TENDER DOCUMENTATION

ACCESS REVIEW - CONCERT HALL

EXECUTIVE SUMMARY

This report is for the assessment of the Concert Hall portion of the Sydney Opera House Renewal Project to assess compliance with the provisions of the Disability Discrimination Act 1992, the Disability (Access to Premises – Buildings) Standard and the National Construction Code together with the relevant Australian Standards.

Figure 3 Extract from L1 Plan – existing Ballet Rehearsal Room

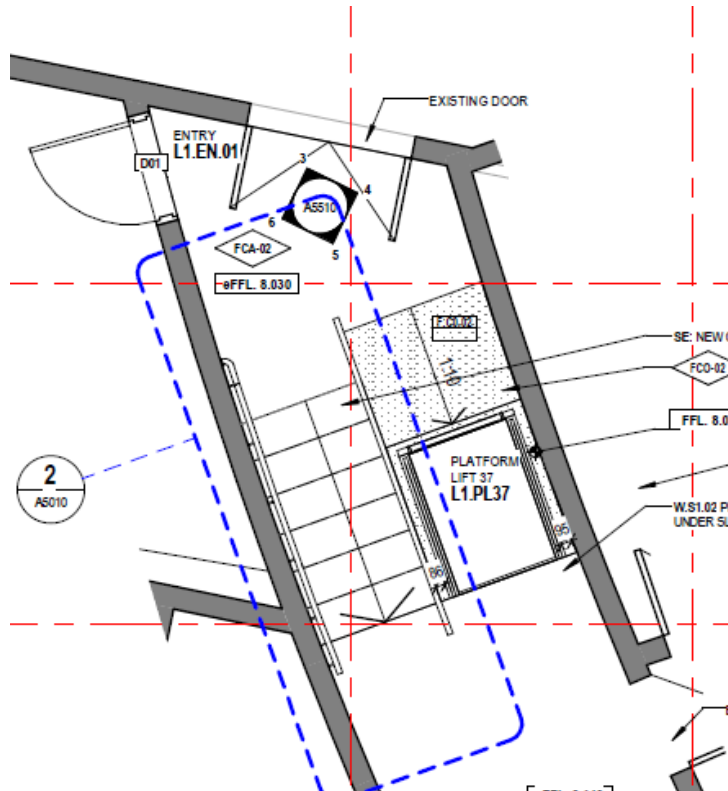
Details of the Platform Lift have been provided on drawing A5510[F]-B1~DETAIL AREA - ENTRY L1 - PLATFORM LIFT 37 - LEVEL 1 +30

The dimensions noted on Detail 5 of drawing A5510 will need to be revised to ensure that the platform lift has a minimum floor dimension of 1100 x 1400mm.

Detail shop drawings will need to be provided from the manufacturer to confirm compliance with the requirements of AS1735.15.

Figure 5 Extract from the plan indicating minimum clearances to be achieved.

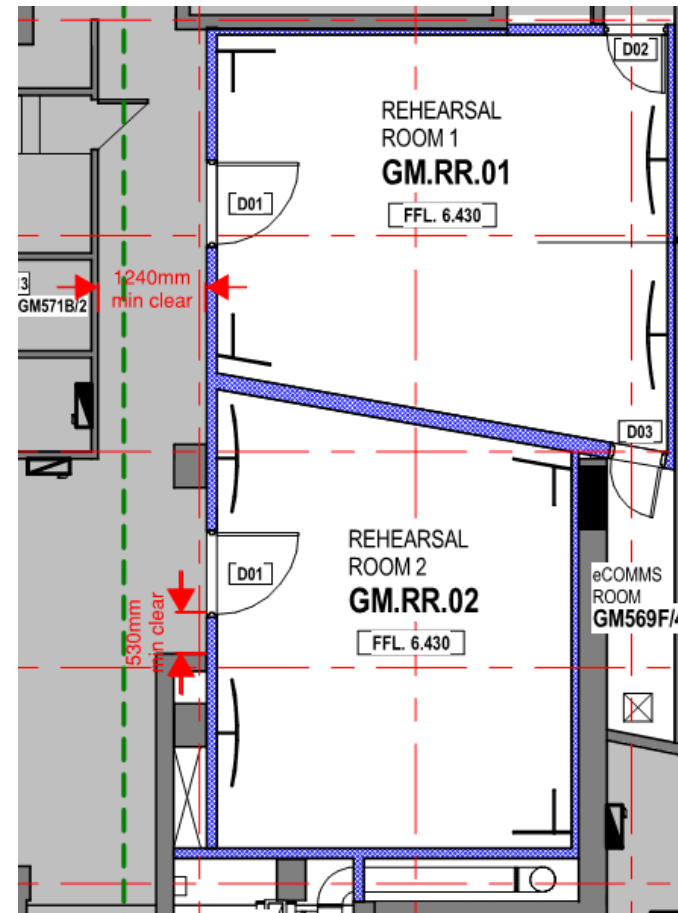
- The minimum clear width of the corridor adjacent to D01 of room GM.RR.01 will need to be not less than 1240mm clear between finishes.
- The door to room GM.RR.02 will need to be positioned in the wall to provide the minimum 530mm required latchside clearances between the door and the acoustic reflector and the door and the existing wall on the corridor side of the room.

- The door threshold detail at both doorways is to be level (3mm max junction between floor finishes)
- If a built-in amplification system is provided to the Rehearsal Room, then a Hearing Augmentation System will need to be provided compliant to the provisions of NCC Clause D3.7 and AS1428.5:2010 will need to be provided.

Figure 7 Extract from the L1 Plan indicating the minimum clear internal dimensions of the accessible WC to be achieved.

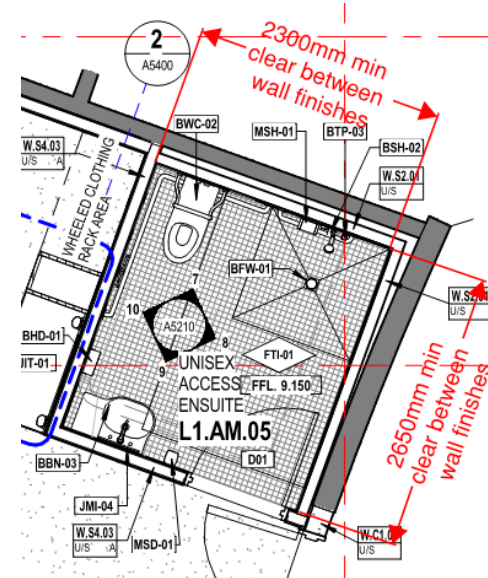
The details for the layout of this accessible WC facility are nominated on drawing A5210[F]-B1~DETAIL AREA - DRESSING ROOM 58 L1-02 - LEVEL 1 +30.

The drawing provided is not dimensioned. The extract from the plan following indicates the minimum clear internal dimensions of this accessible WC facility to be achieved. The dimensions noted are the minimum clear internal dimensions between wall finishes.

The internal layout of the accessible WC and Shower will need to satisfy the minimum requirements nominated at Clause 15 of AS1428.1:2009.

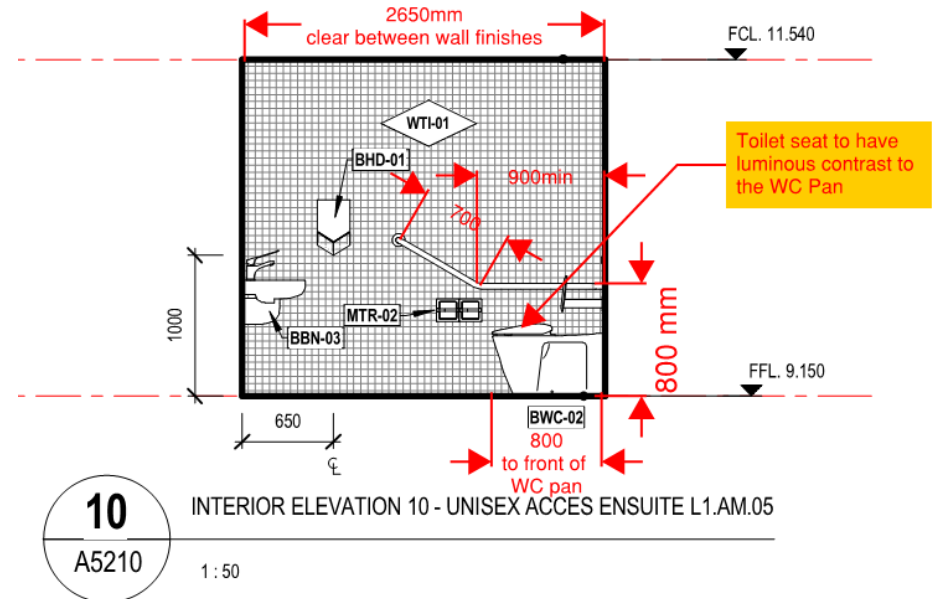
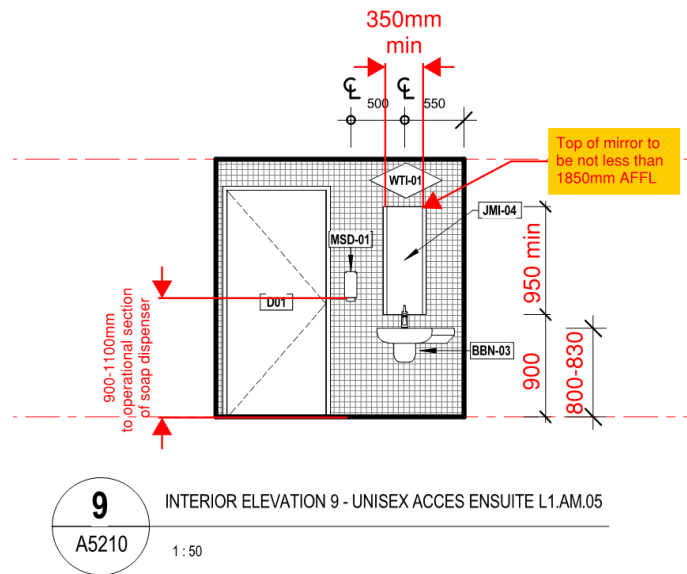
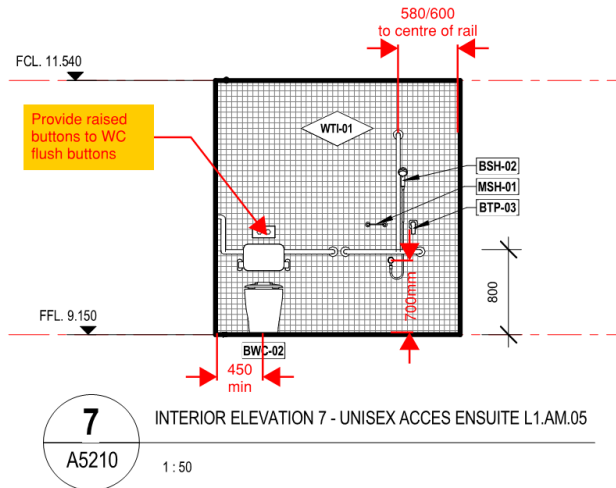
The following markups of the plan indicate the minimum requirements to be achieved in the setting out of the fixtures of this accessible WC.

6.2. Accessible Ensuite – L1.AM.12

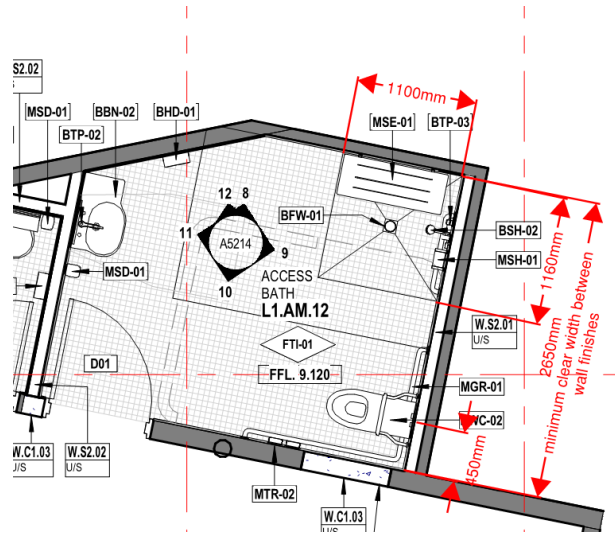
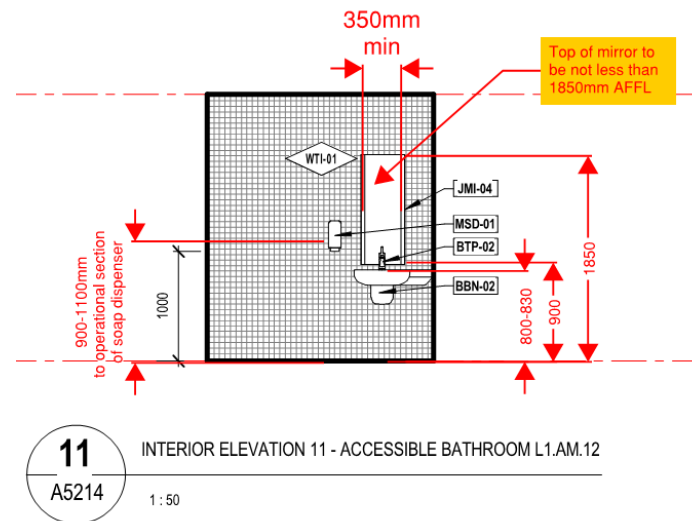
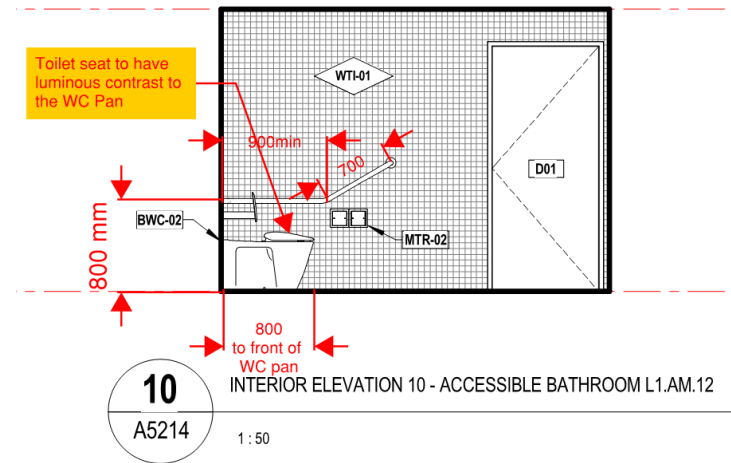
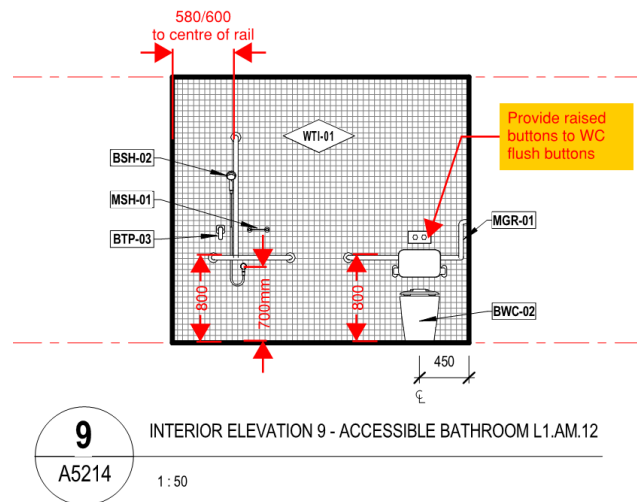
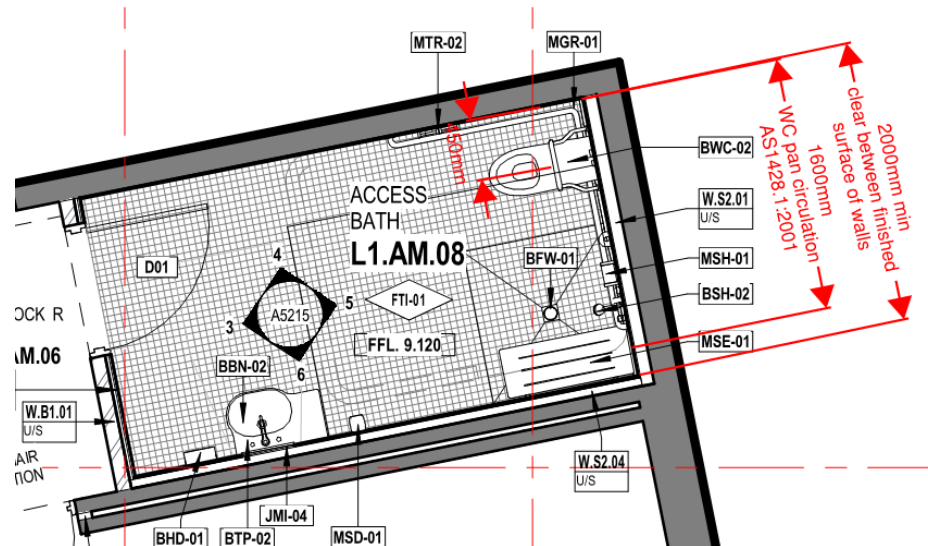
The details for the layout of this accessible WC facility are nominated on drawing A5214[F]-B1-DETAIL AREA - DRESSING ROOM 75 L1-AM-10, BATH L1-AM-11 & ACCESS BATH L1-AM-12 - LEVEL 1 +30

The drawing provided is not dimensioned. The extract from the plan following indicates the minimum clear internal dimensions of this accessible WC facility to be achieved. The dimensions noted are the minimum clear internal dimensions between wall finishes.

The internal layout of the accessible WC and Shower will need to satisfy the minimum requirements nominated at Clause 15 of AS1428.1:2009.

The following markups of the plan indicate the minimum requirements to be achieved in the setting out of the fixtures of this accessible WC.

6.3. Accessible Ensuite – L1.AM.08

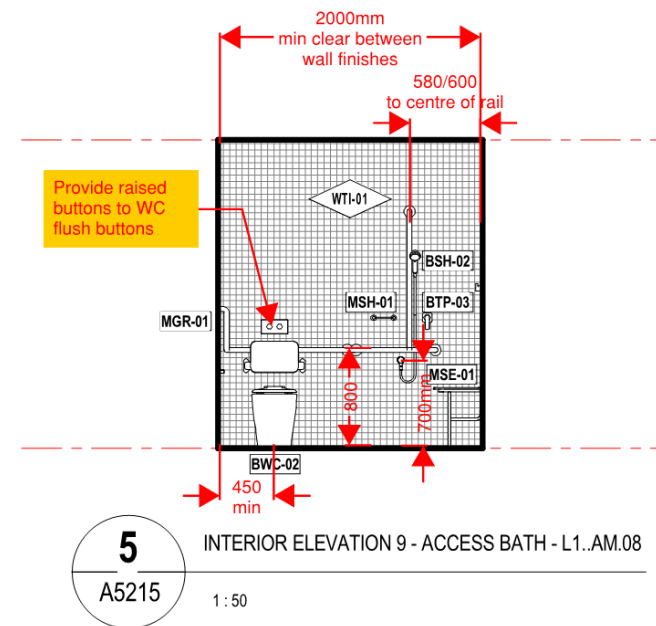
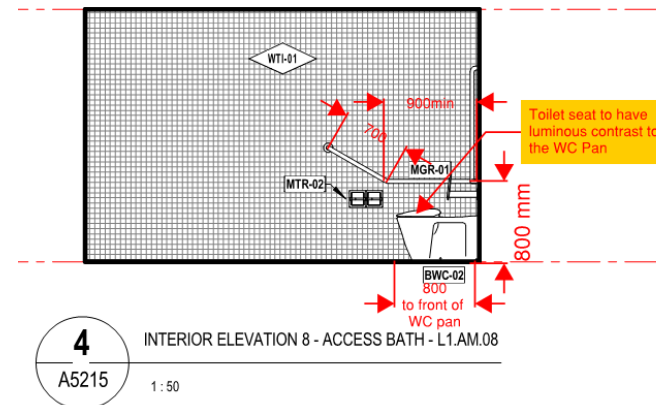
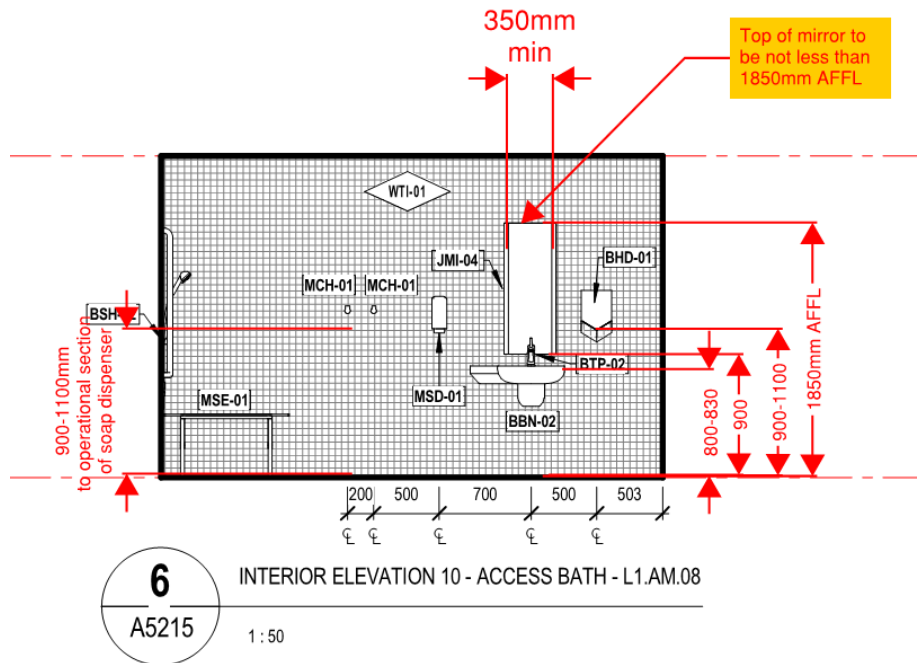
The details for the layout of this accessible WC facility are nominated on drawing A5215[F]-B1~DETAIL AREA - DRESSING ROOM 76 L1-AM-07 & ACCESS BATH L1-AM-08 - LEVEL 1 +30

The works proposed to this ensuite relate to the refurbishment of an existing ensuite. The concessional provisions noted at Clause 4.5 – Toilet Concession of the disability (Access to Premises – Building) Standard have been applied to the spatial arrangements of this accessible WC facility.

The drawing provided is not dimensioned. The extract from the plan following indicates the minimum clear internal dimensions of this accessible WC facility to be achieved. The dimensions noted are the minimum clear internal dimensions between wall finishes.

The internal layout of the accessible WC and Shower will need to satisfy the minimum requirements nominated at Clause 15 of AS1428.1:2009.

Figure 8 Extract from L1 Plan

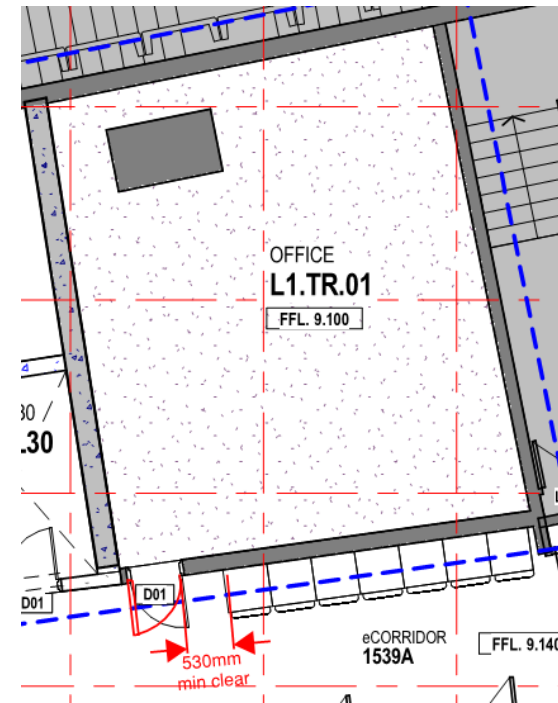
The handing of the door will need to be reversed to provide compliant latchside clearances to satisfy the requirements of Clause 13.3 of AS1428.1:2009.

Figure 10 Extract from the plan indicating the step transitions at the entrance to the Concert Hall.

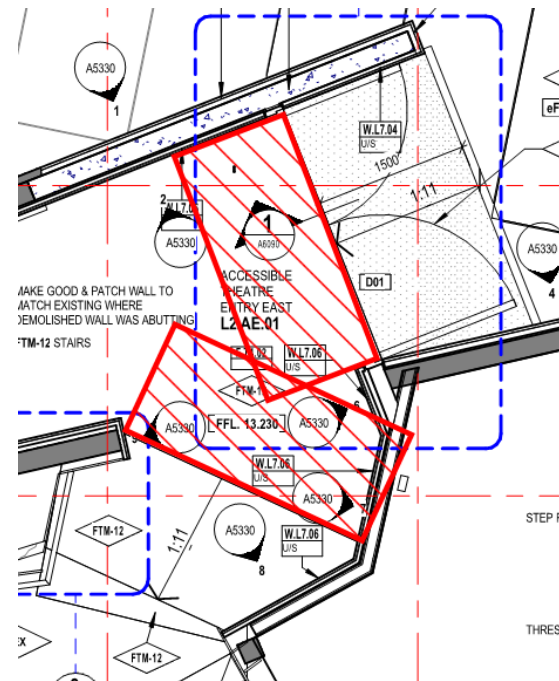
To address the change in levels between the Foyer areas and the entries to the Concert Hall 1:11 step ramps have been provided. The available area precludes the provision of a 1450mm landing zone immediately in front of the doors to the Concert Hall. When performances are not in progress the doors to the Concert Hall are locked. Access to the theatre is by arrangement. Visitors are escorted by Opera House personnel. The requirement for wheelchair patrons or visitors to the Opera House to

independently operate the doors to the concert Hall is not applicable in this instance. Prior and post performances the doors to the Concert Hall are opened by the Staff thereby negating the need for the horizontal circulation zones at the doors. The zone immediately within the theatre is level and acts as the landing at the top of the step ramp.

The provisions of NCC Clause D3.11 indicates that the landings for a step ramp must not overlap a landing for another step ramp or ramp. The extract from the plan following indicates that there is a slight overlap of parts of the landings associated with the step ramps entering the Concert Hall. It is not considered that the extent of the overlap is significant. It is considered that the requirement of NCC Clause D3.11 are satisfied by this design.

12.3. Accessible WC – L1.AM.03

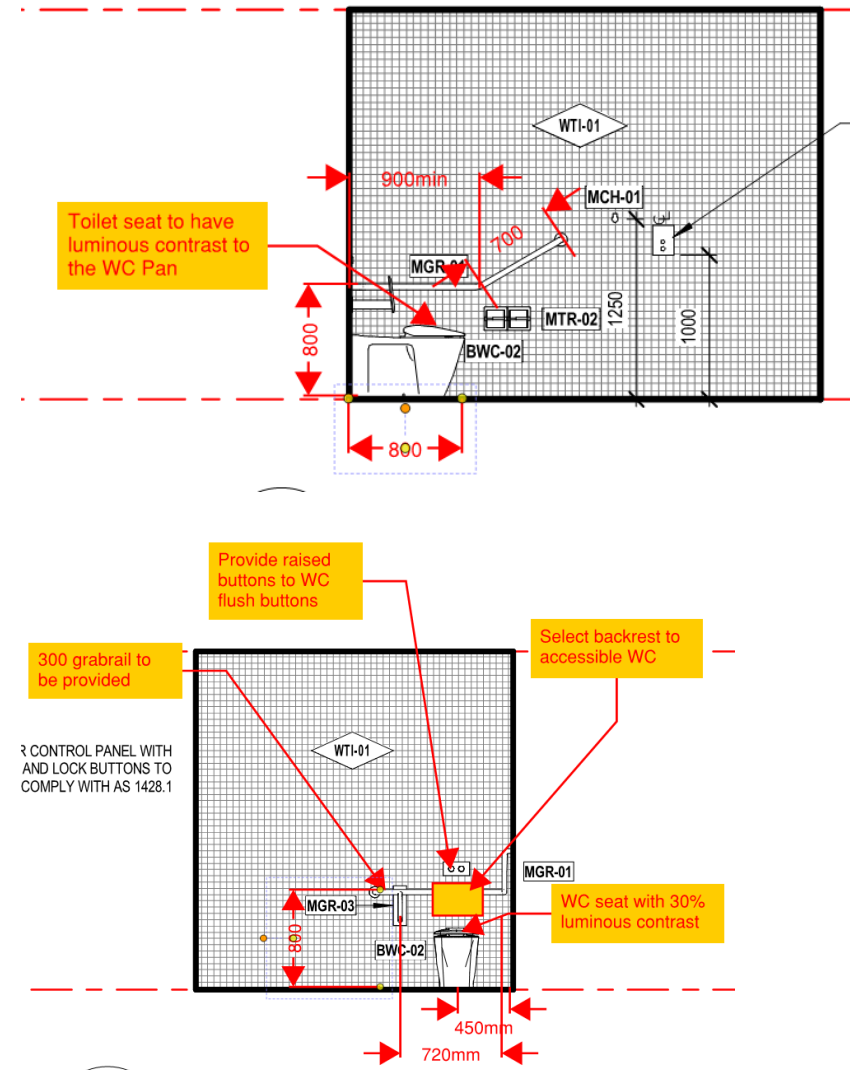
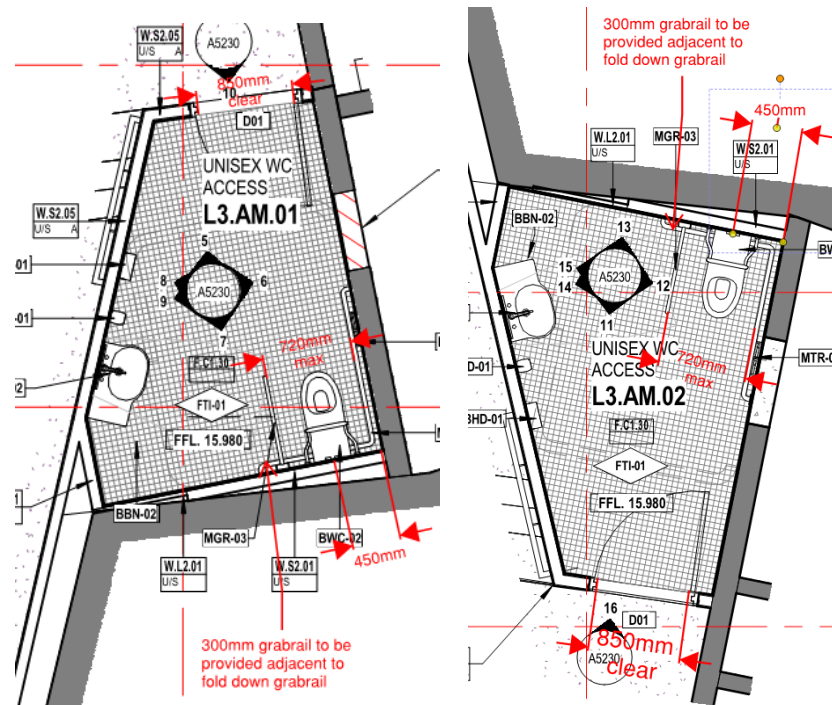
The details for the layout of this accessible WC facility are nominated on drawing A5211[F]-B1~DETAIL AREA - MALE PERFORMER AMENITIES L1-AM-02 & UNISEX ACCESSIBLE WC L1-05

The drawing provided is not dimensioned. The extracts from the plan following indicate the minimum dimensions of these accessible WC facilities to be achieved.

The setout of the fixtures within the accessible WC presently do not satisfy the requirements of AS1428.1:2009. The detailed construction documentation will need to satisfy the requirements of Clause 15 of ASA1428.1:2009

12.4. Accessible WC – L3.AM.01 and L3.AM.03

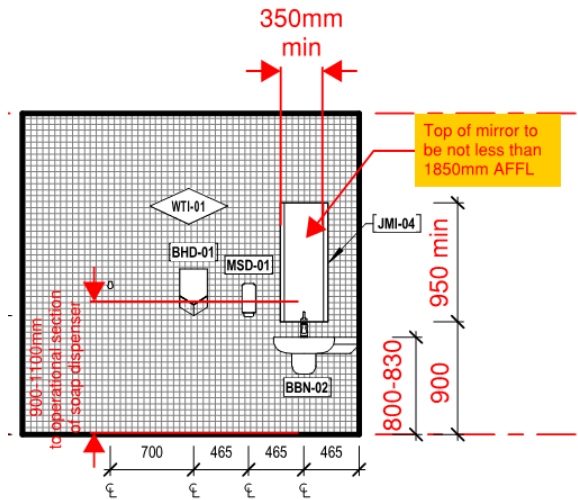
The details for the layout of this accessible WC facility are nominated on drawing A5230[F]-B1~DETAIL AREA - MALE ACCESS L3-01 & FEMALE ACCESS L3-02 - LEVEL 3 +51

The drawing provided is not dimensioned. The extracts from the plan following indicate the minimum dimensions of these accessible WC facilities to be achieved.
